IM3 (Jolie) Discrete 256M & UMA Block Diagram

Title: Schematic Block Diagram

Size: Document Number IM3 (XPS-Jolie) Rev 2A

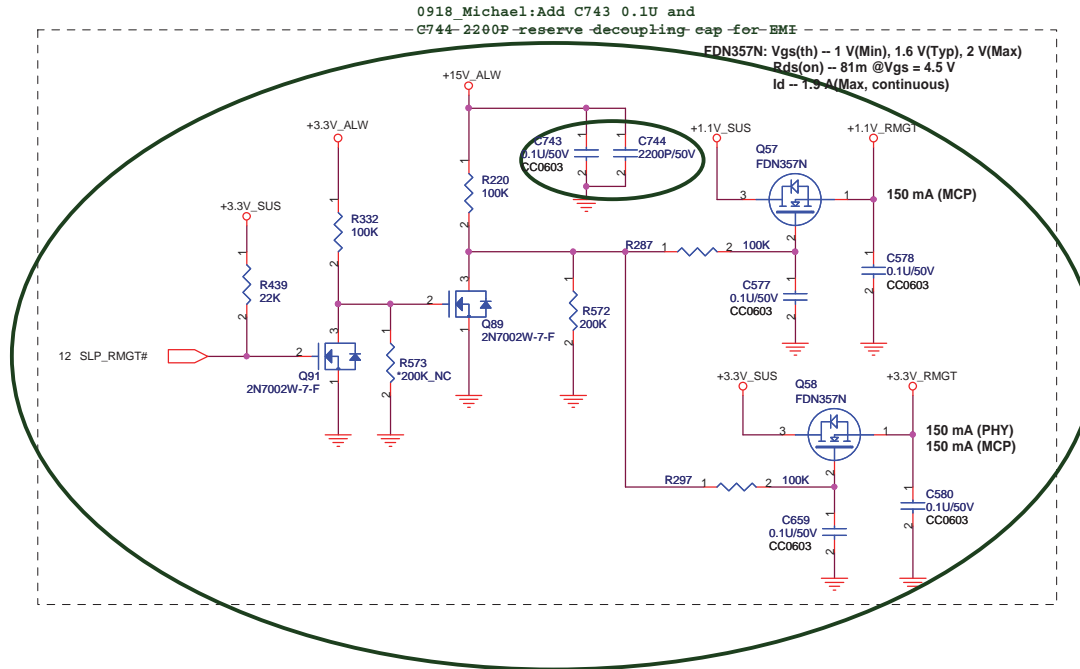
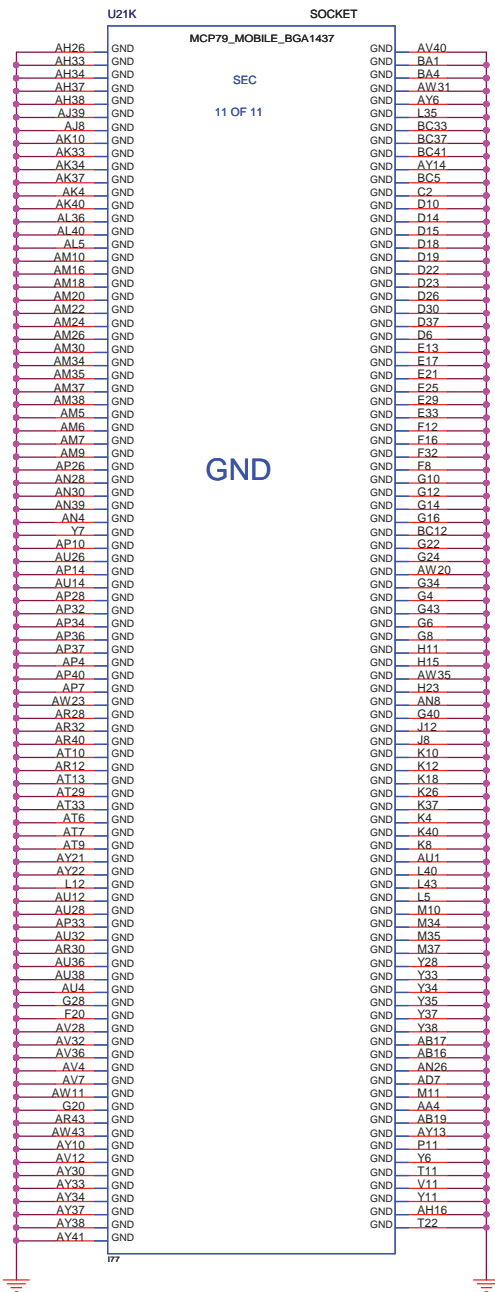
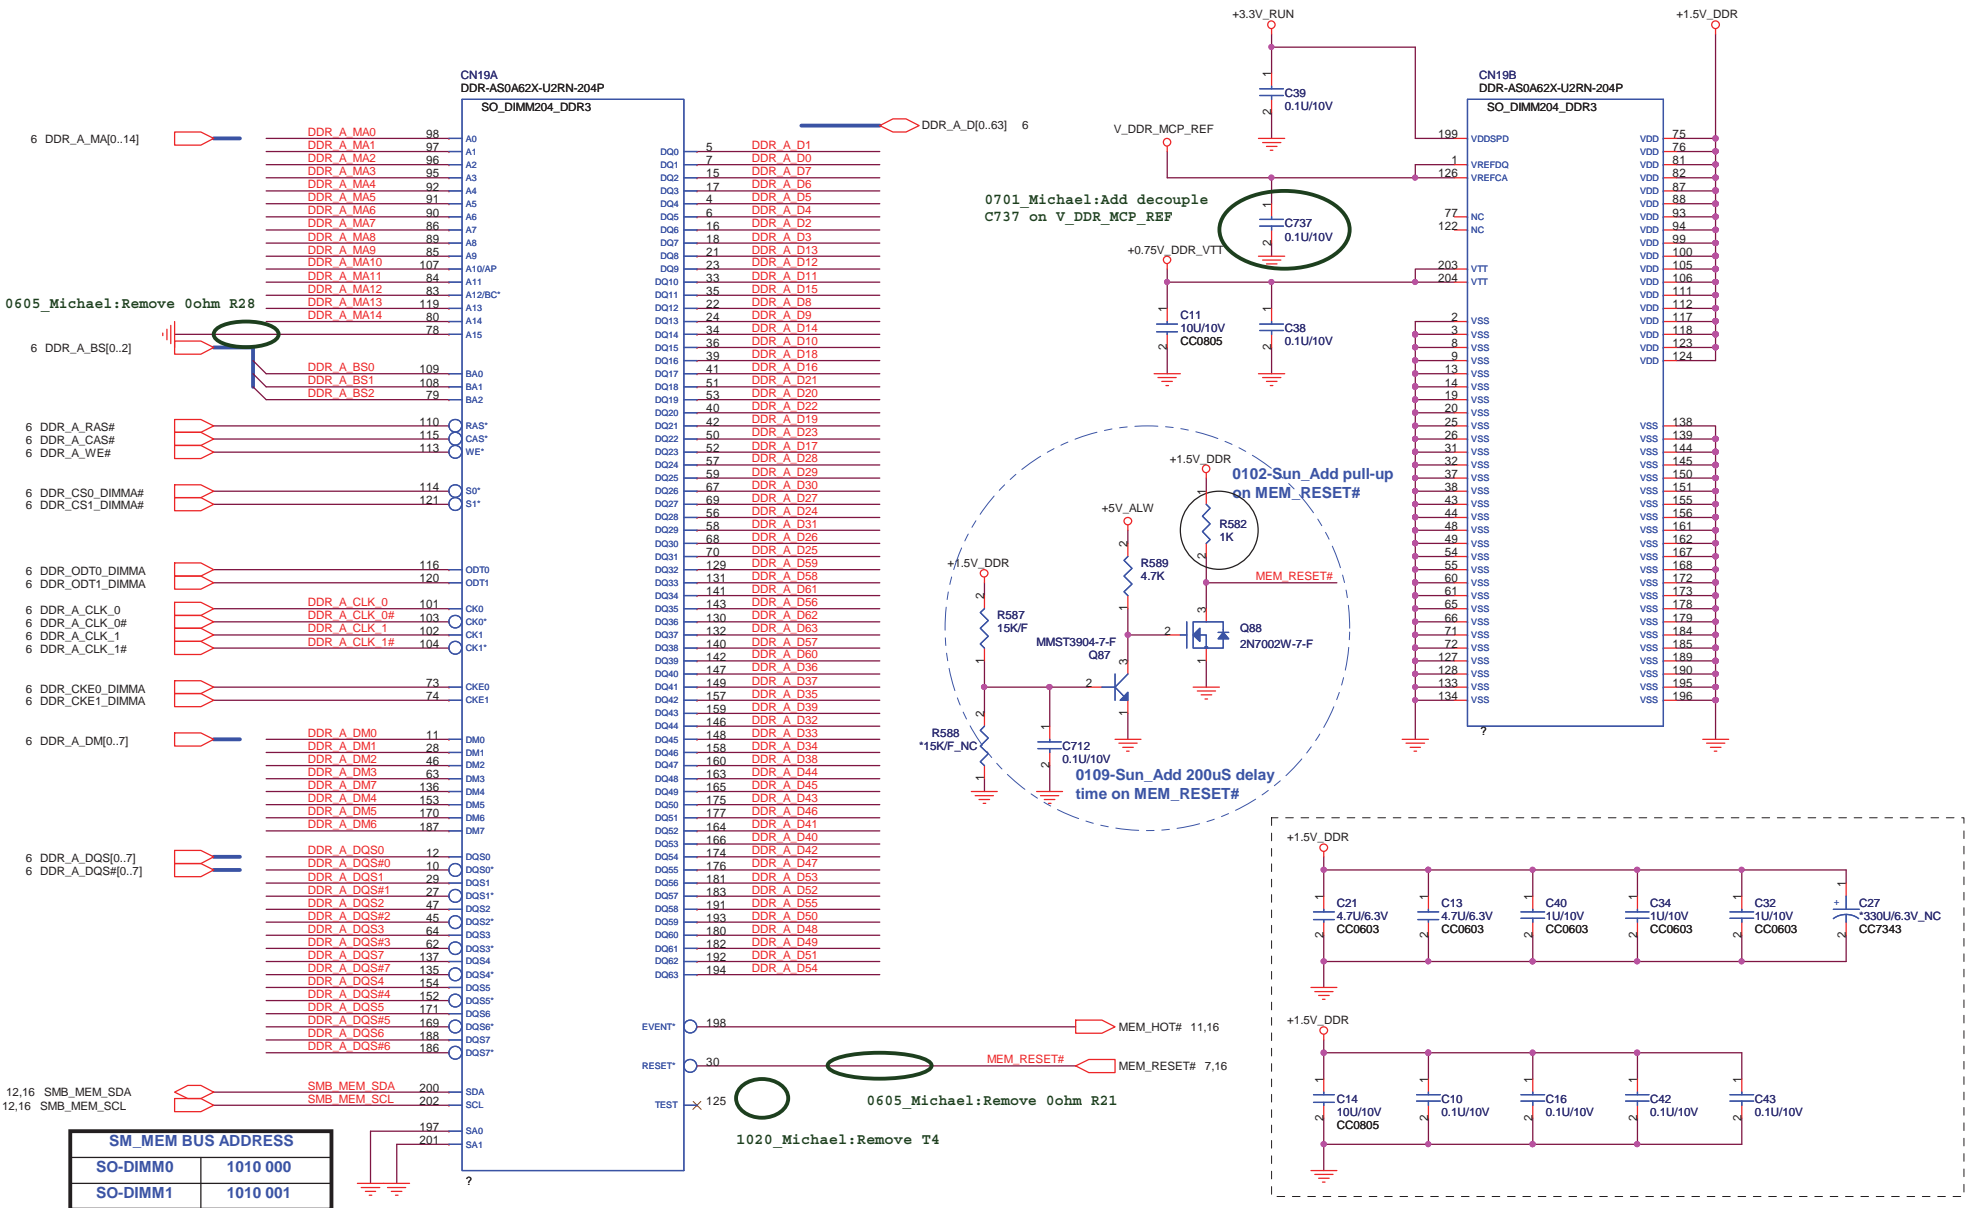
0229-Sun 1.1V_RMGT & +3.3V_RMGT MOSFET Vgs aren't enough issue, modify circuit reference NV CRB (Del JP11, JP12)

Change Q57 from SI2304BDS-T1-E3 to FDN357N, Q58 from SI2304BDS-T1-E3 to SI2301BDS-T1-E3

Add Q89 with 2N7002, R591 with 10K

0825 Michael: Change Q58 type from SI2301BDS to FDN357N and add MOS 2N7002W-7-F, R&C for +1.1V_RMGT and +3.3V_RMGT power low issue

Title: MINI-CARD (WLAN)

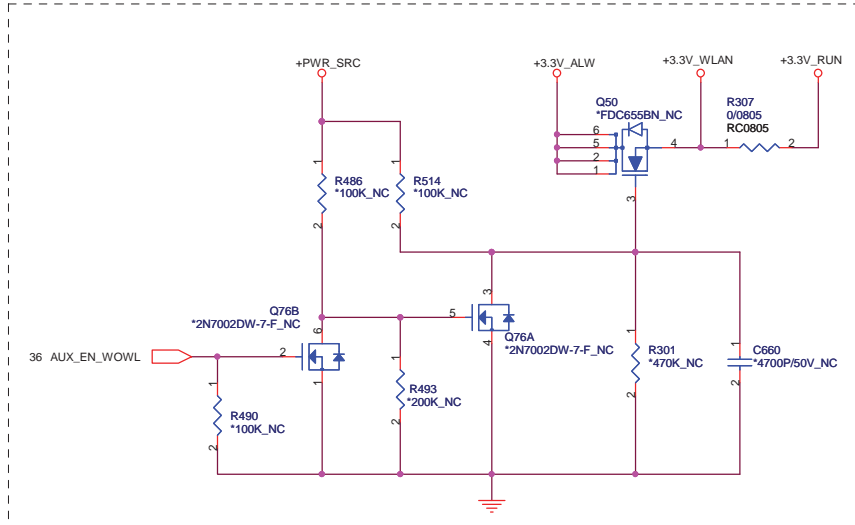
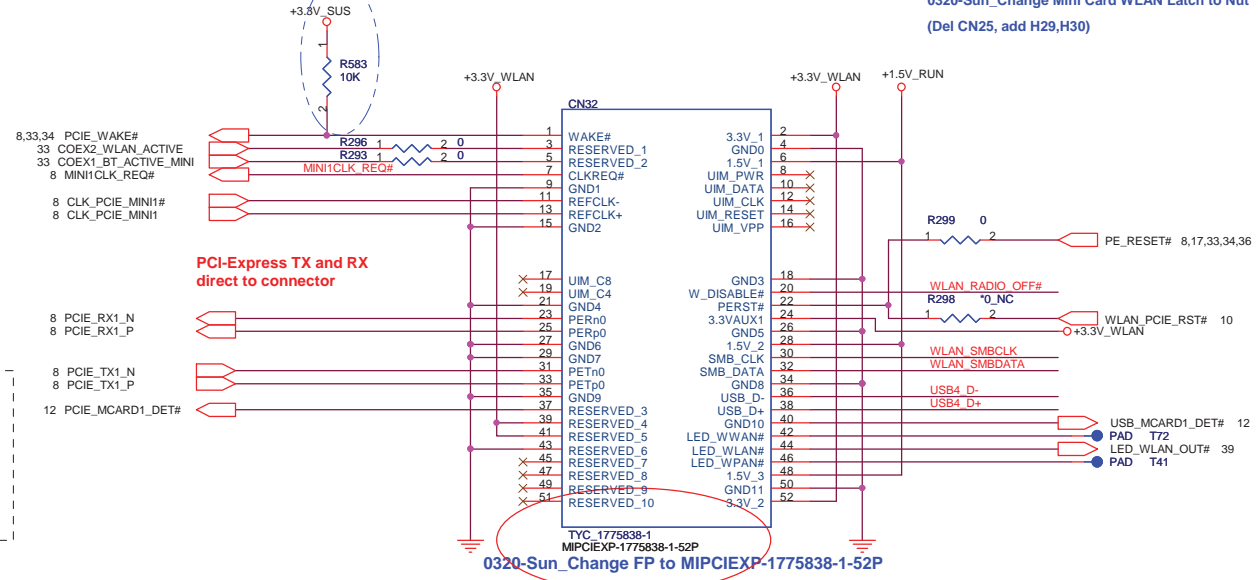
0320-Sun_Change Mini Card WLAN Latch to Nut
(Del CN25, add H29,H30)

AZALIA (HD) CODEC

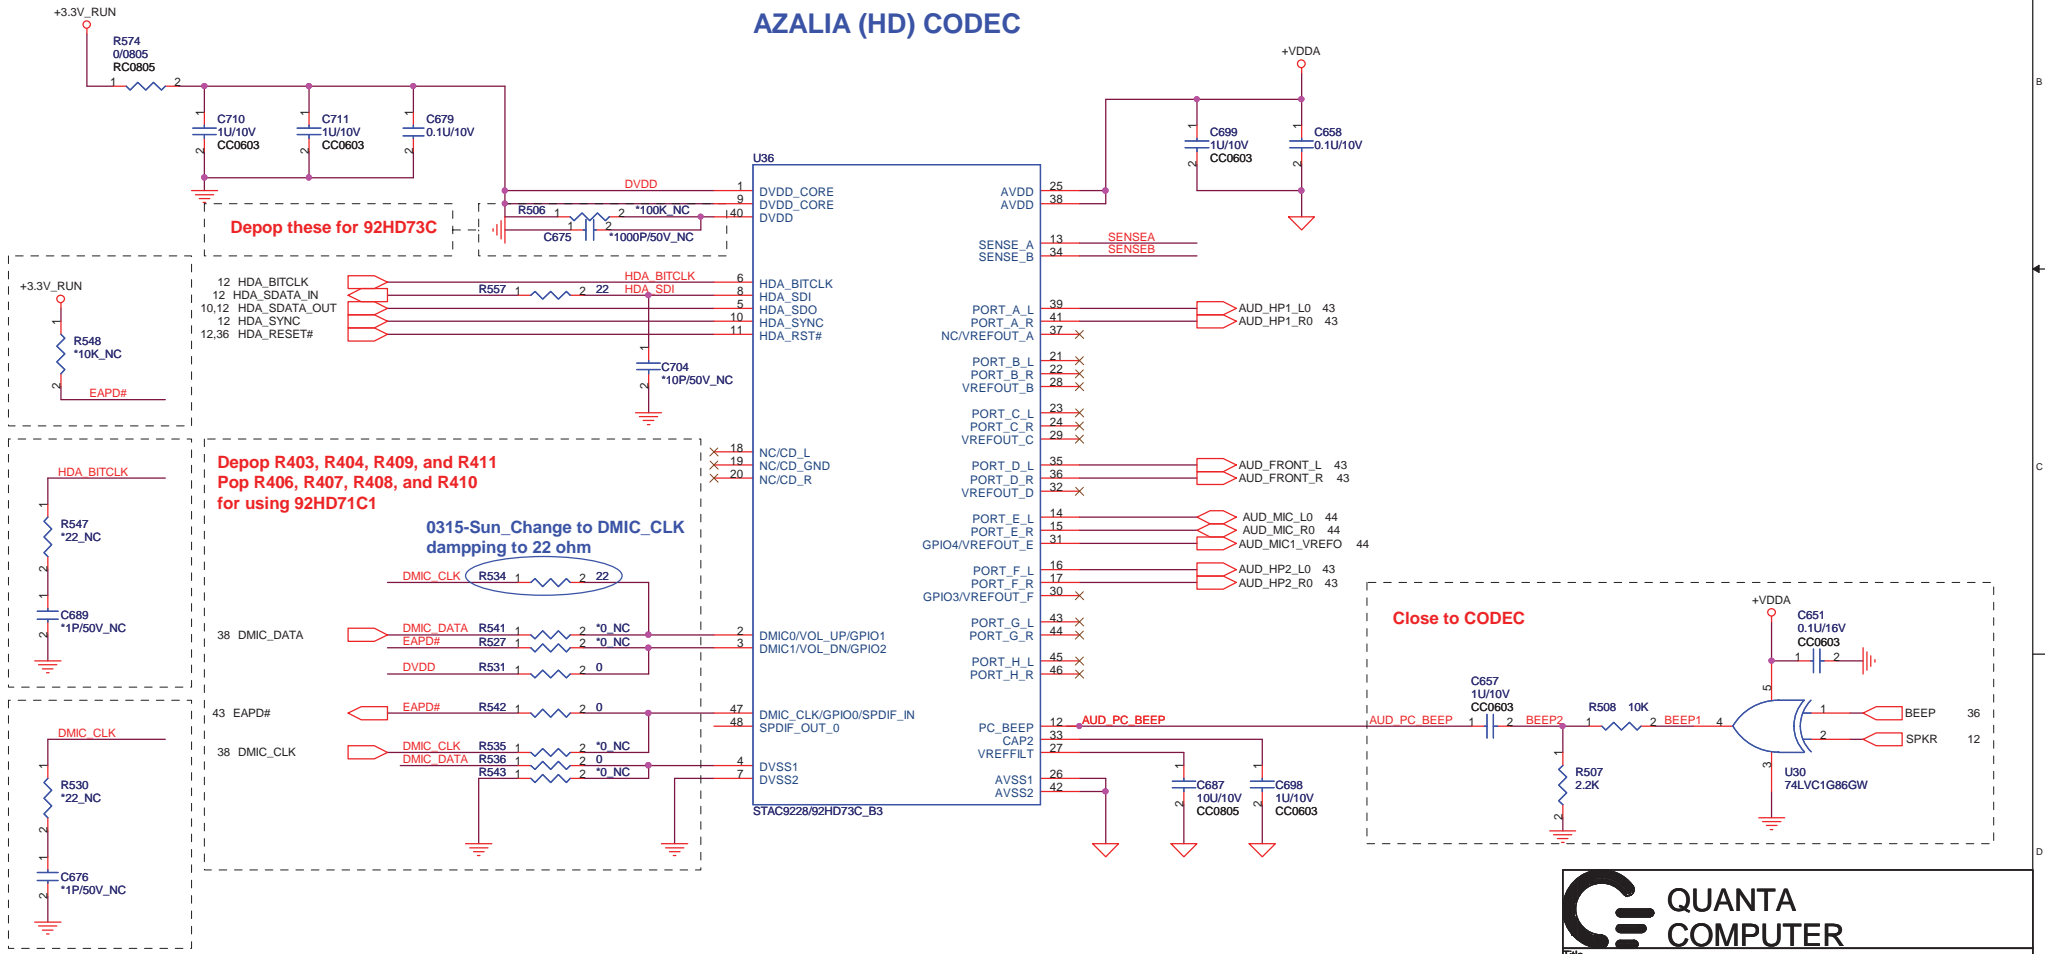
0315-Sun_Improve Dynamic Range.
0320-StegeChange AC coupling to 10U/10V

0310-Sun_Improve Dynamic Range.
Add R597,R598 w/2.2K

0315-Sun_Improve Dynamic Range.
Pop C452,C455 to 330P

Headphone Jack

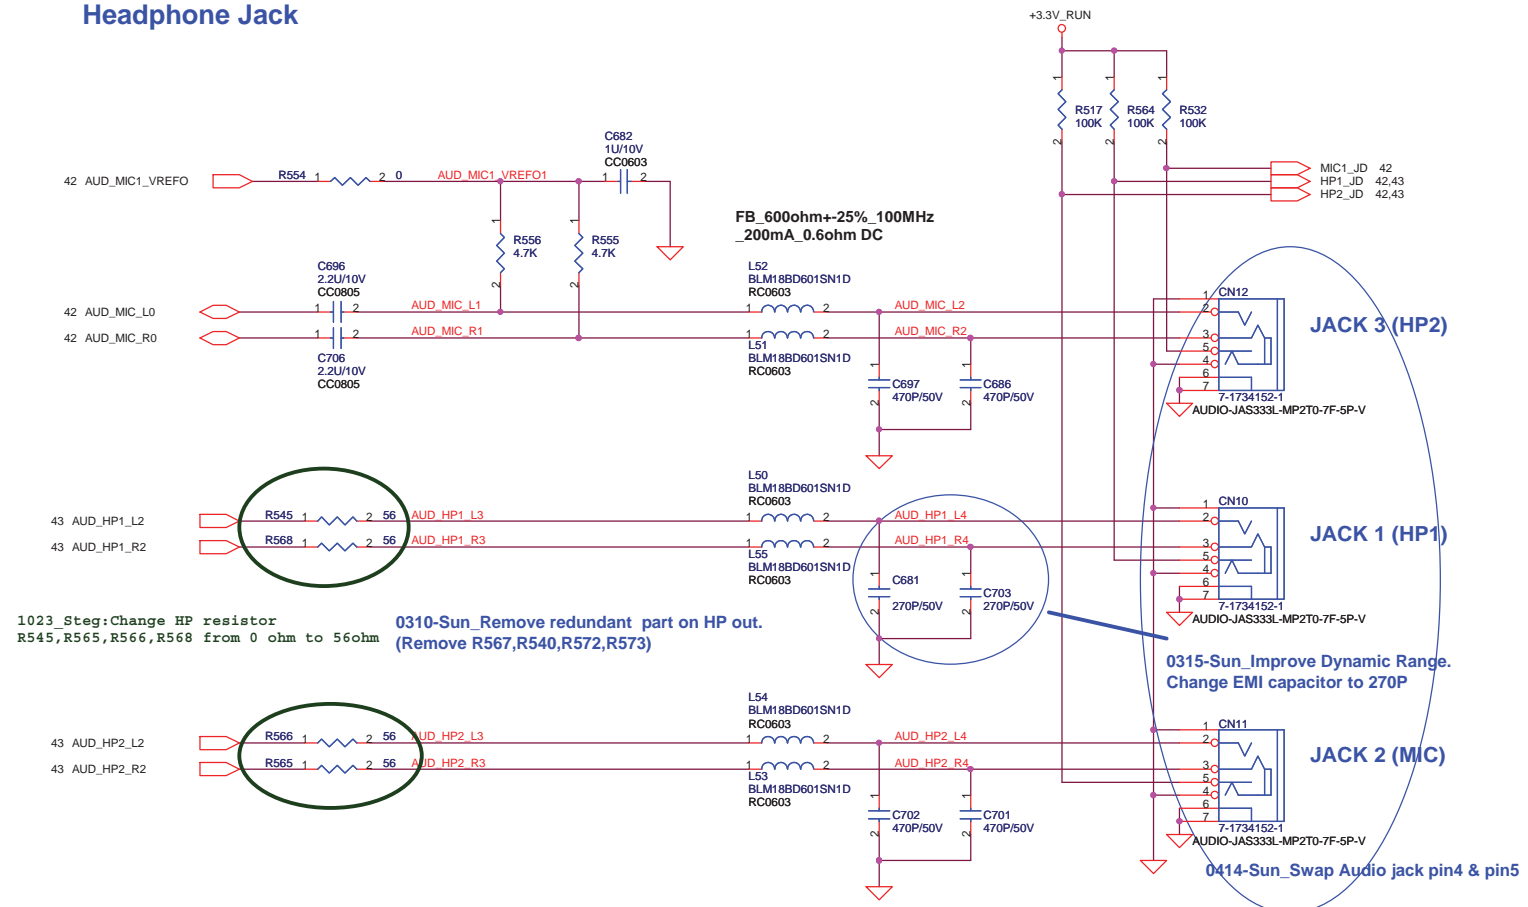
1023_Step: Change HP resistor
R545, R565, R566, R568 from 0 ohm to 56ohm

0310-Sun_Remove redundant part on HP out.
(Remove R567, R540, R572, R573)

0315-Sun_Improve Dynamic Range.
Change EMI capacitor to 270P

0414-Sun_Swap Audio jack pin4 & pin5

TRANSFORMER

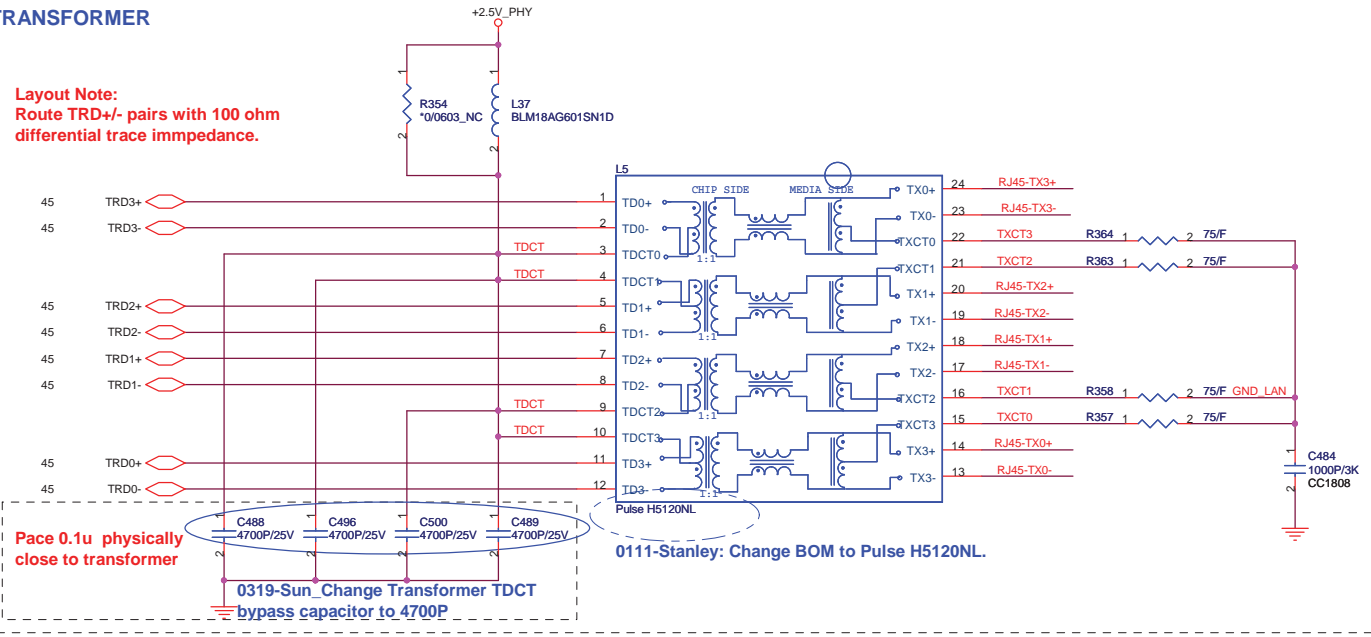
0319-Sun_Change Transformer TDCT bypass capacitor to 4700P

0111-Stanley: Change BOM to Pulse H5120NL.

RJ-45 Connector

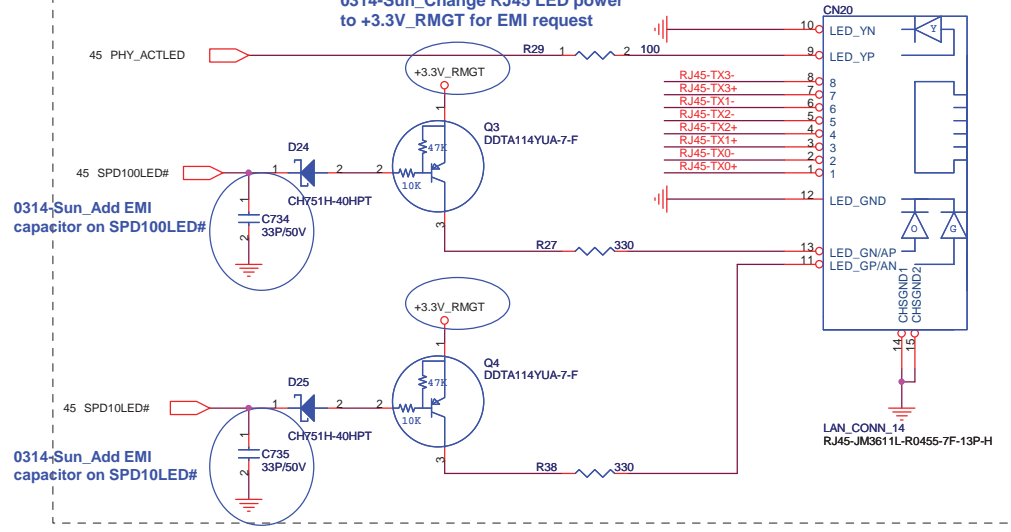
0314-Sun_Change RJ45 LED power to +3.3V_RMGT for EMI request

0314-Sun_Add EMI capacitor on SPD100LED#
